## ADDENDUM 1

To the Contract Documents for the New Parking Lot

Grand Terrace Elementary School  
Colton Joint Unified School District  
SGH Architects Project Number: 22-12105-04  
DSA A#04-122929

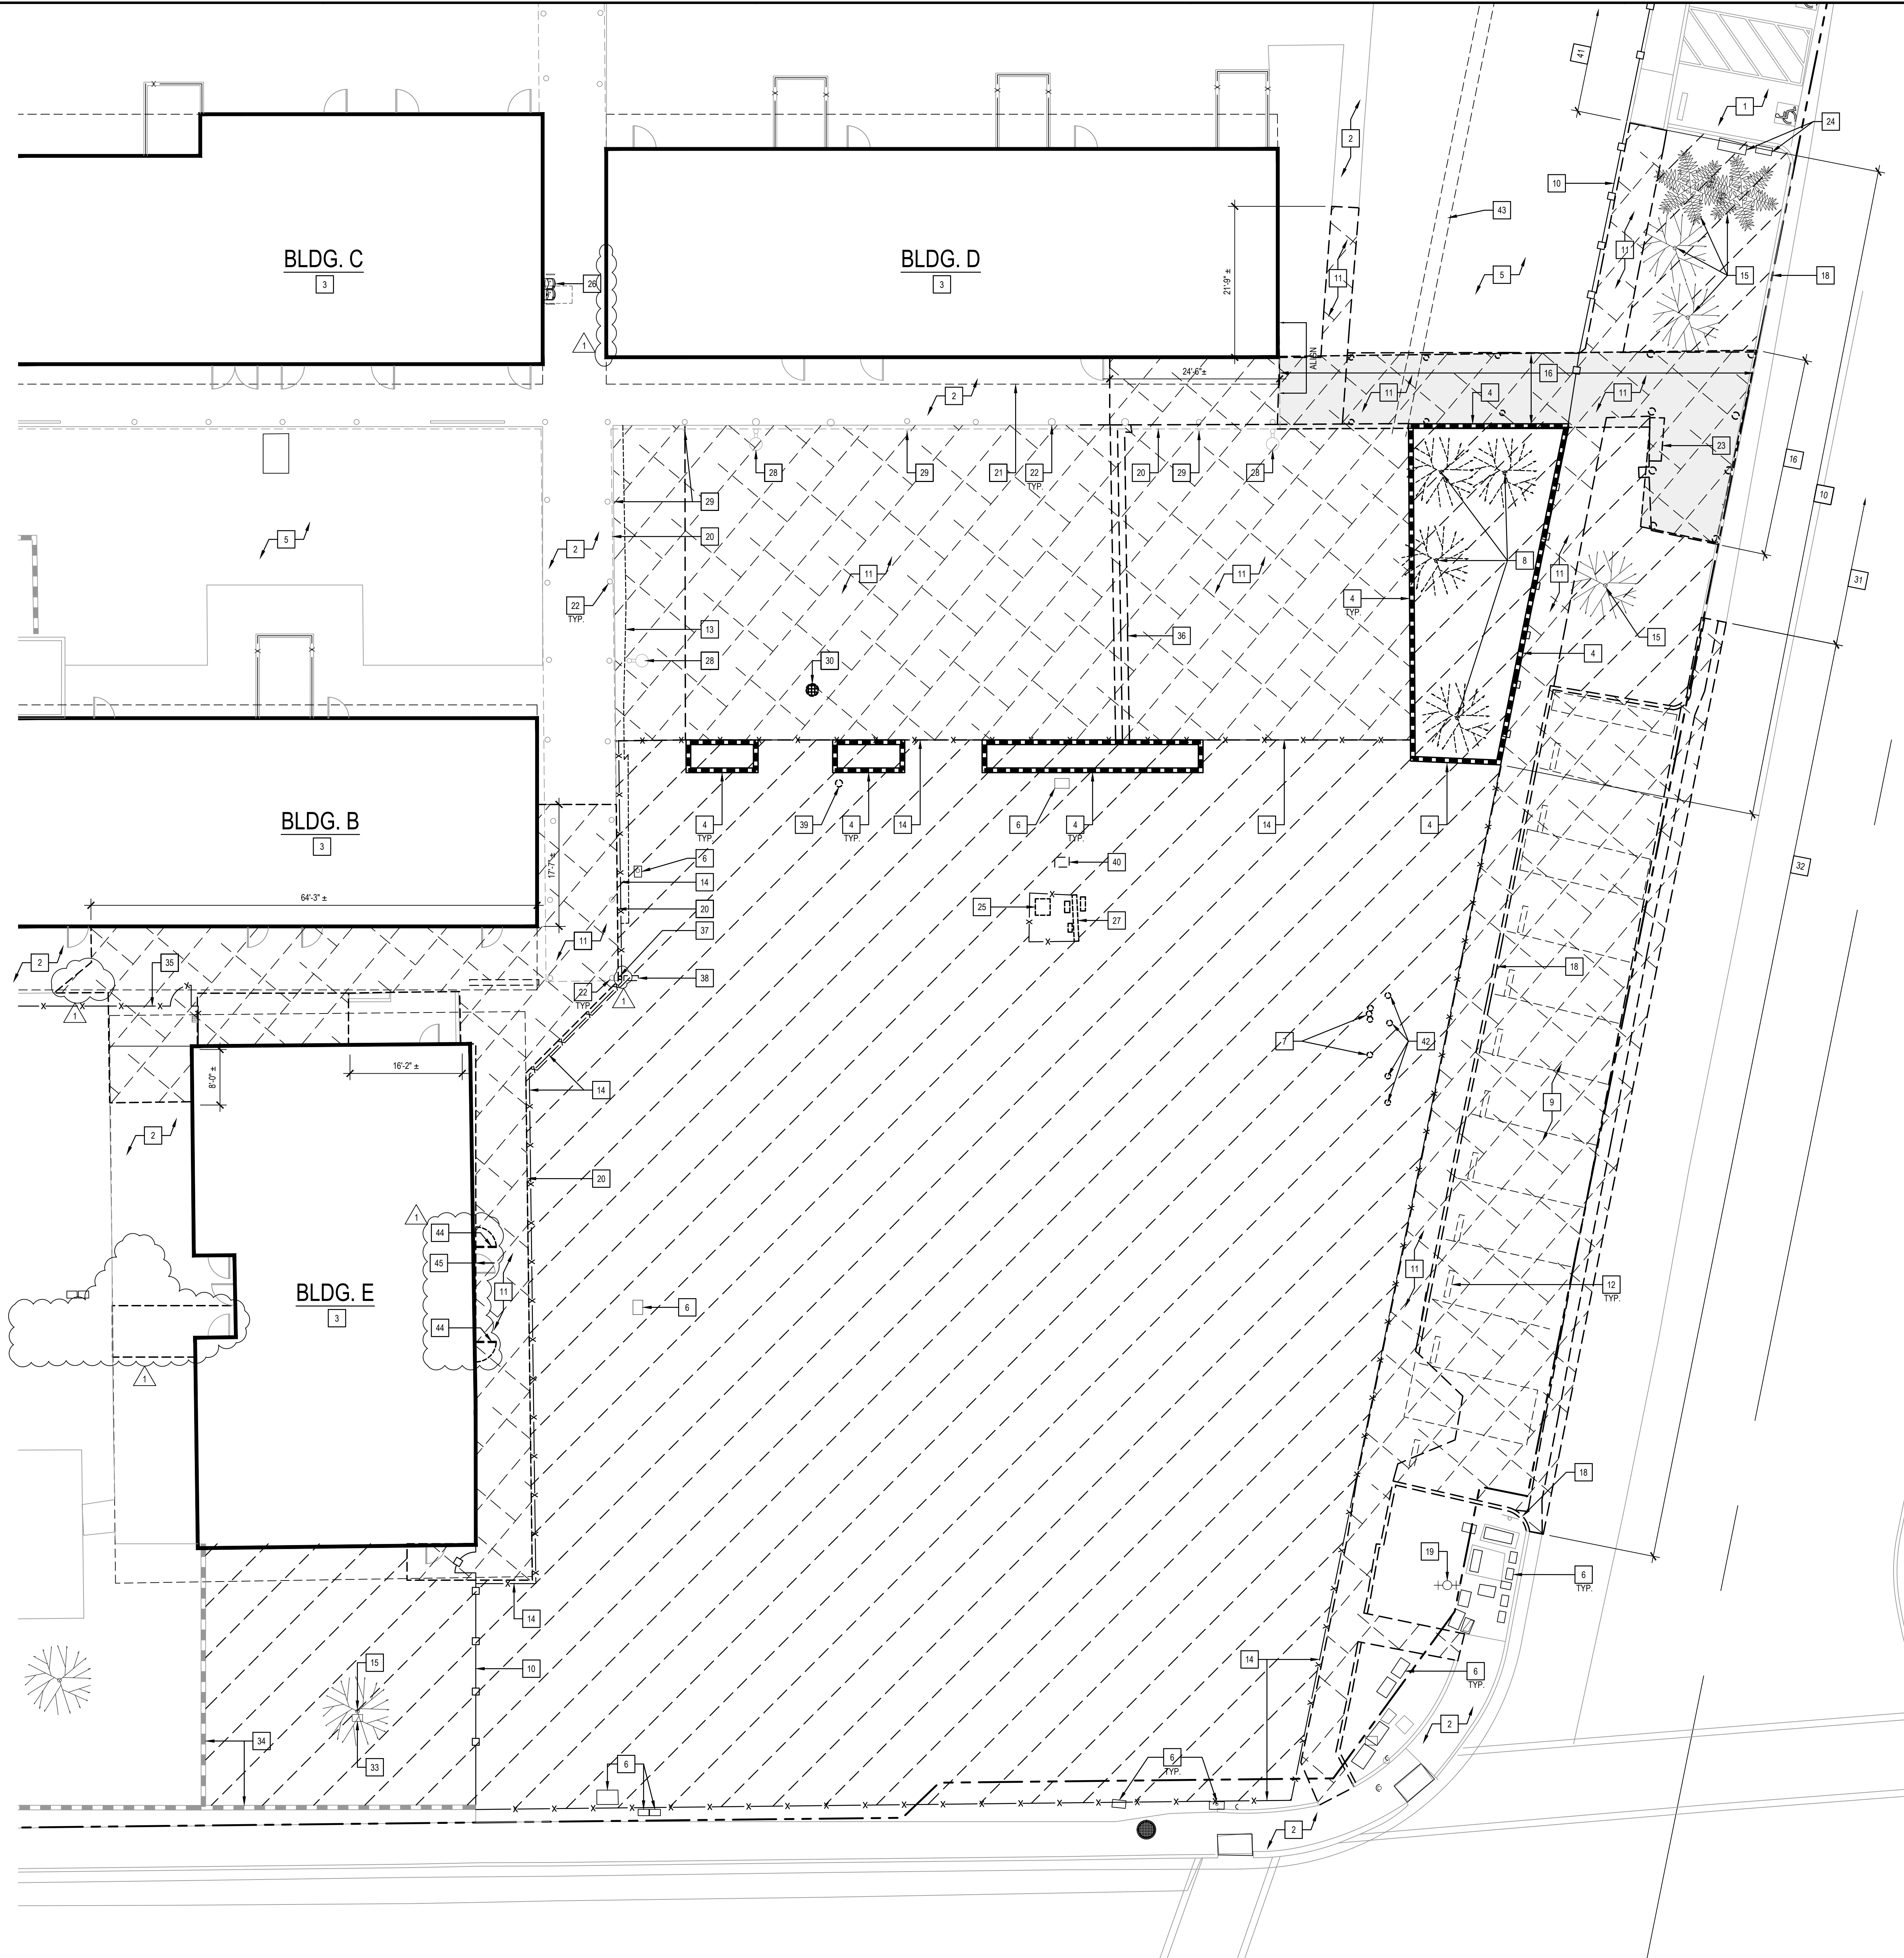
- K. Sheet A1.11 – Site Plan-Enlarged Demolition  
(Attachment 15)
- a. Revised keynote #37 to remove existing gas riser @ canopy post near South/East corner of Building B.

- b. Added keynote #44 to remove (2) mechanical room existing exterior doors to be replaced with new on East wall of Building E.
  - c. Added keynote #45 to remove (1) existing exterior door threshold to be replaced with new on East wall of Building E.

- f. Revised paving sawcut line to align with underground drainpipe layout near North/West corner of Building E and South of Building B.
- L. Sheet A1.12 – Site Plan-Enlarged Remodel  
(Attachment 16)

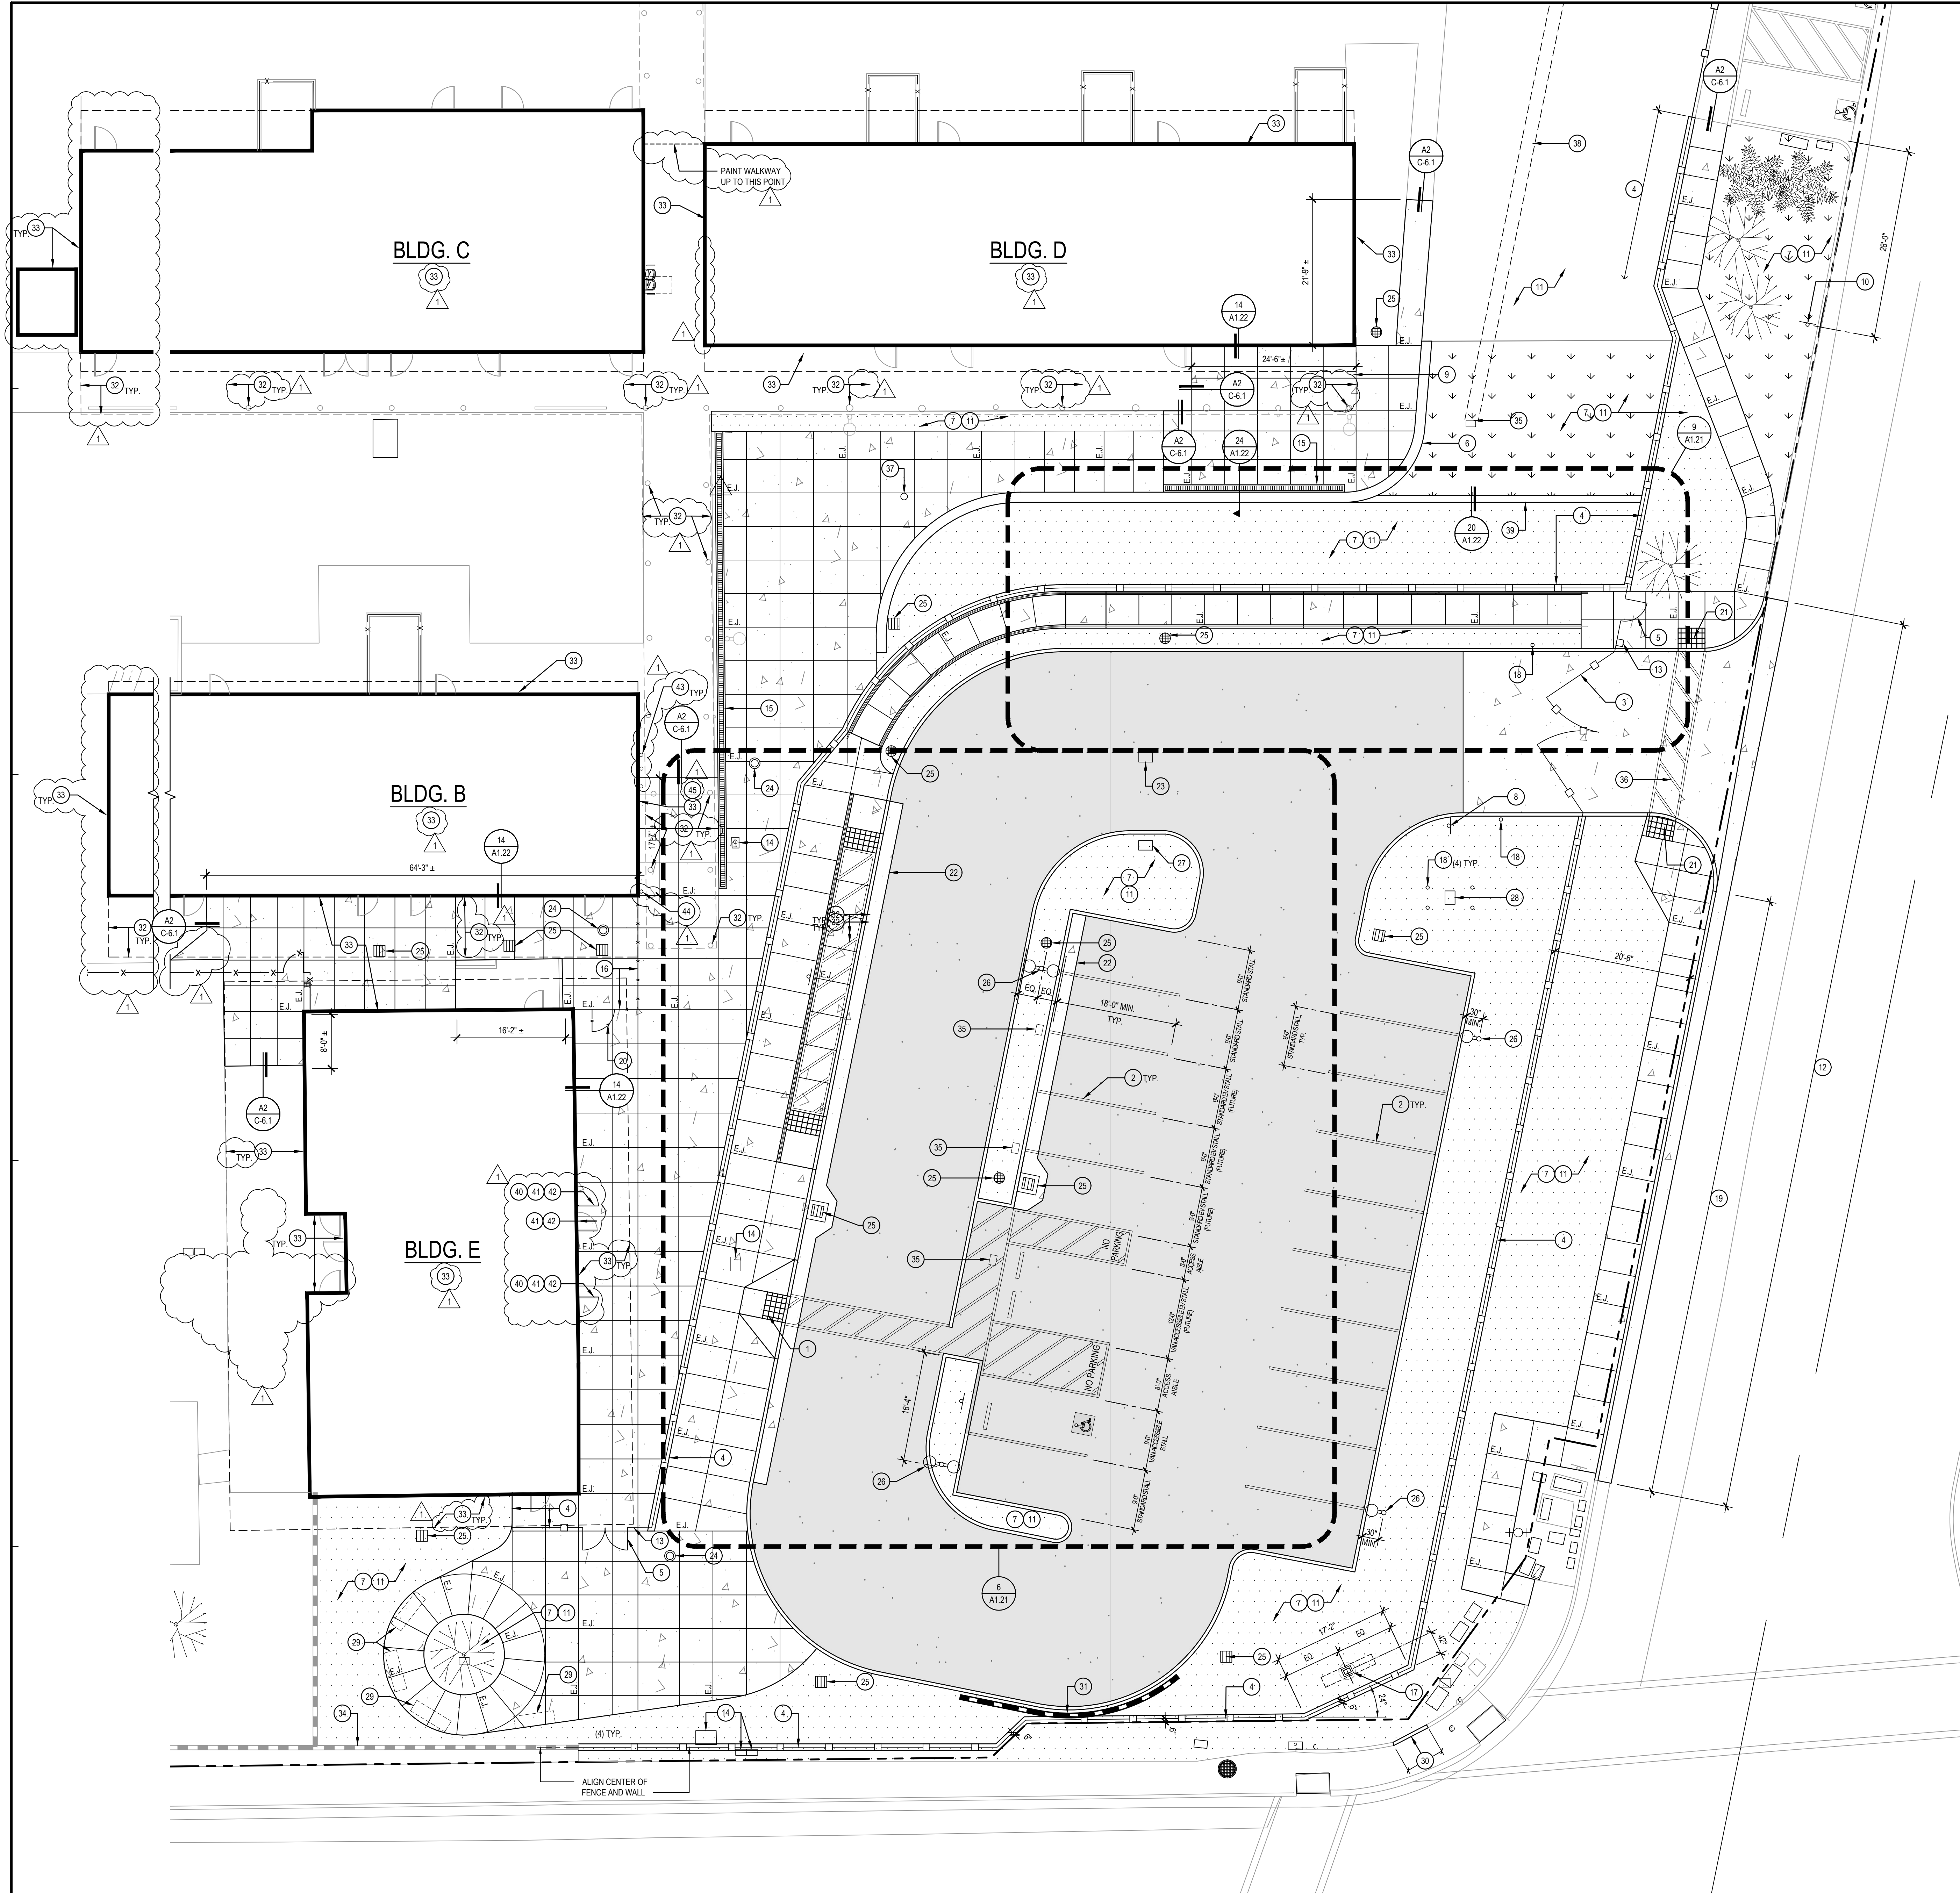
- a. Added keynote 12 to see City of Grand Terrace Street Improvement Plans.
  - b. Added to keynote #30 to see City of Grand Terrace Street Improvement Plans.

- c. Revised keynote #32 to paint covered walkway and to be more specific of areas and components to be painted.
  - d. Added keynote #32 to covered walkways between Buildings B, C, D and E.

- e. Revised keynote #33 to paint building and to be more specific of areas and components to be painted.

- f. Added keynote #33 under names of Buildings B, C, D and E.
  - g. Added keynote #40 to replace (2) exterior doors with new on East wall of Building E.

- h. Added keynote #41 to paint (3) doors on East wall of Building E.
  - i. Added keynote #42 to provide new door thresholds at (3) doors on East wall of Building E.

- j. Added keynote #43 to note electrical conduits near North/East corner of Building B.
  - k. Added keynote #44 to note gas riser near South/East corner of Building B.

- l. Added keynote #45 to scrape off the finish plaster coat and provide new finish coat on East wall of Building B.
  - m. Added general note #10.
  - n. Added general note #11.

- q. Added portion of West sides of Buildings B and C and keynote #33.
  - r. Revised paving line to align with underground drainpipe layout near North/West corner of Building E and South of Building B.
